NUMBER: 08-014-04

SUBJECT:

Radio Intermittent Audio

This bulletin involves applying a label over slots in the radio top cover.

Fig. 1 COVER SLOTS

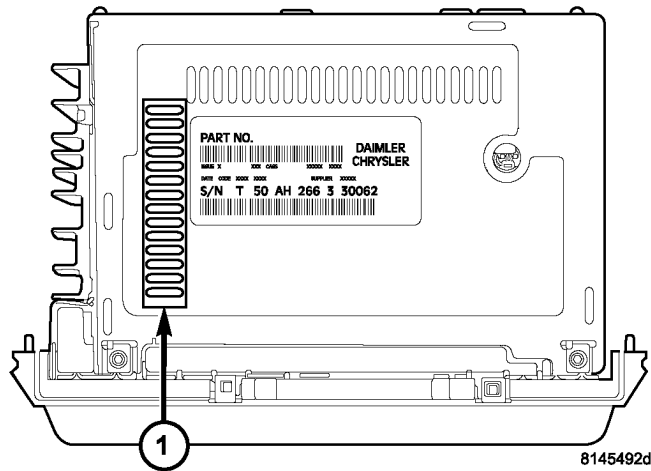
Audio drops out when vehicle is moved from cold to warm or humid environment. Condensation builds up across the audio amplifier circuitry causing amplifier to shut down. Typically, cycling ignition switch Off and back On will restore the audio output.

1. Remove radio from Instrument panel. Wiring connectors can remain connected.
2. Place 3M Vinyl Plastic Electrical Tape Super 33+ or Equivalent over the row of slots on the left hand side of the radio top cover, be sure to not cover information (barcode, etc.) on the radio's primary label (Fig. 1). Be sure the slots are covered completely and the tape is sealed all around the edges. Also cover and seal with tape, the two slots between the heat sink and the row of covered slots.

1 - COVER SLOTS COMPLETELY

NOTE: The two slots between the heat sink and the row of covered slots (1) also need to be completely covered and sealed with tape.
